**PROPOSED DWELLINGHOUSE,  
ARTARMAN ROAD,  
RHU**

**VARIATION TO PLANNING CONSENT REF 20/00267/PP  
CONDITION NUMBER 7**

**SUPPORTING STATEMENT**

# Proposed Residential Property, Artarman Road, Rhu – Access Technical Note

Title  
**SITE ACCESS VISIBILITY SPLAY**

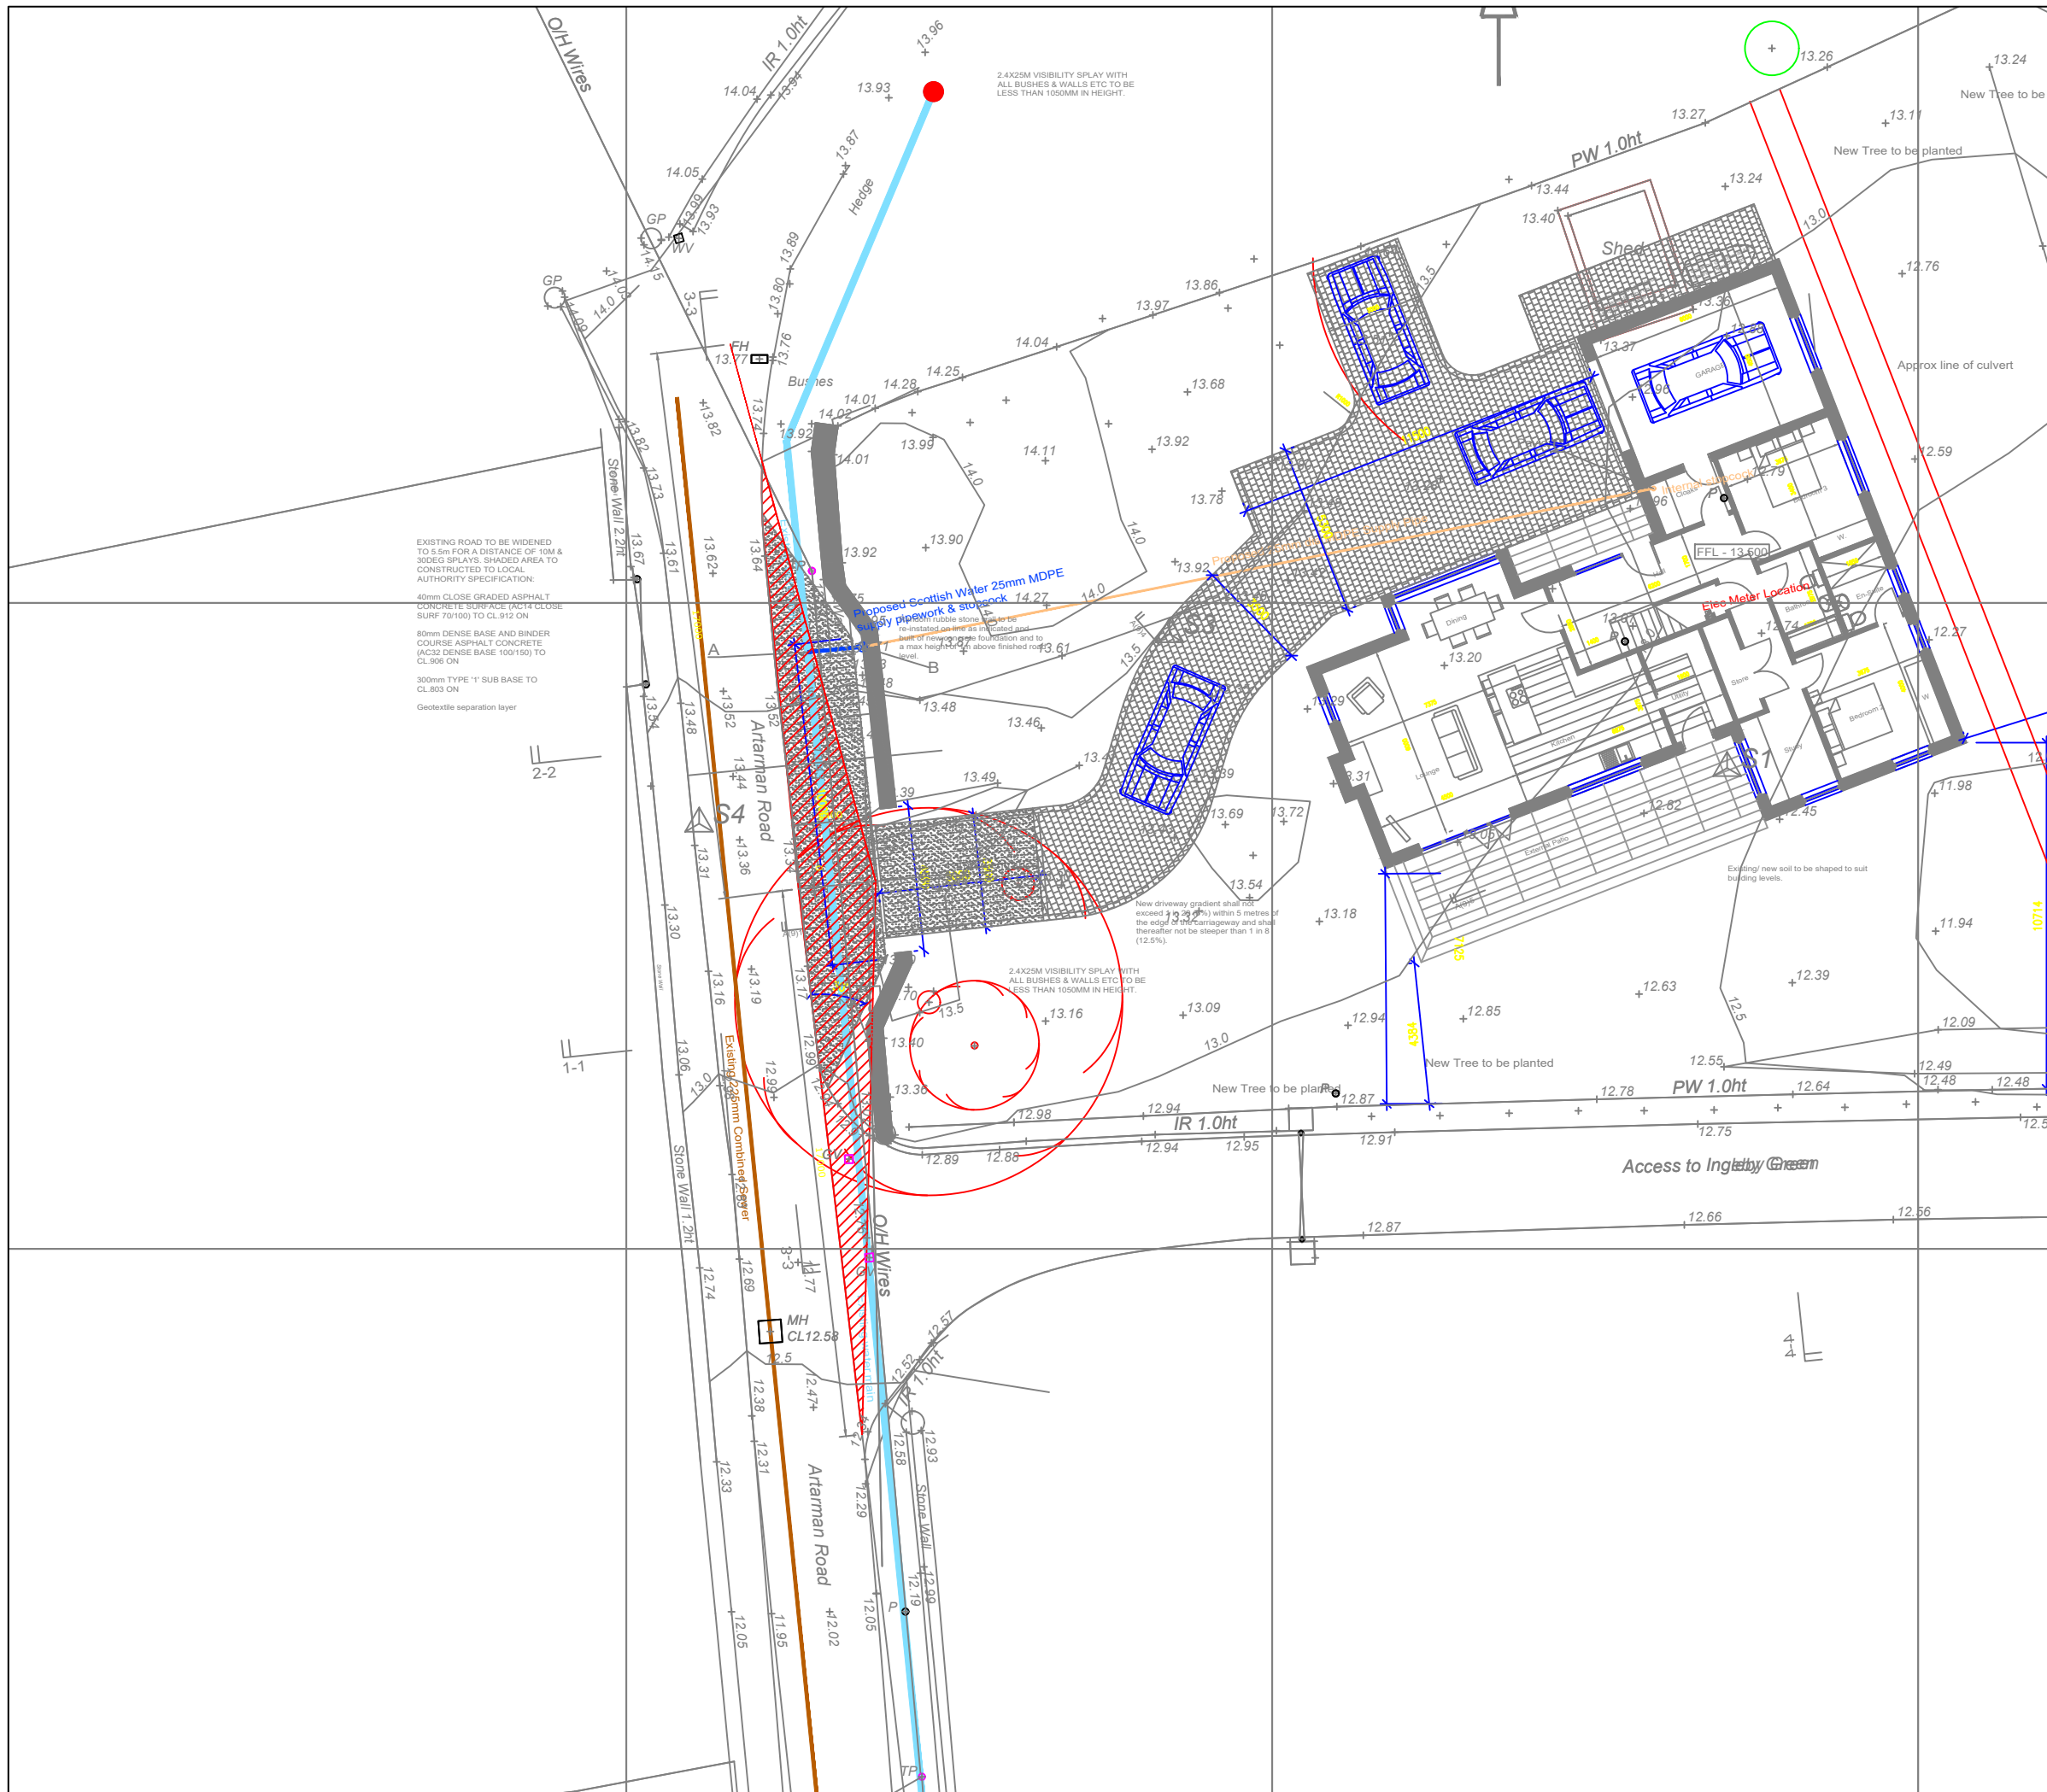
ECS drawing 21054-001 contained within *Appendix B* indicates that the required visibility splay as per the guidance contained within the Designing Streets policy document can be achieved, however, the Y distance is measured to the centre point of the carriageway to avoid third party land to the north. As Artarman Road is a single carriageway road the proposed splay will still ensure that all vehicles negotiating the route are visible from the proposed access thereby confirming that there is no reduction in the visibility envelope proposed.

The visibility splay achievable from the proposed access meets the required of the measured road speed therefore it is considered that Condition 7 of the planning consent should be amended to reflect this submission.

The applicants thereby seeks the rewording of Condition 7 to reflect the visibility splay demonstrated within ECS drawing 21054-001.

Note:  
 Visibility Splays 2.4m x 17m ———
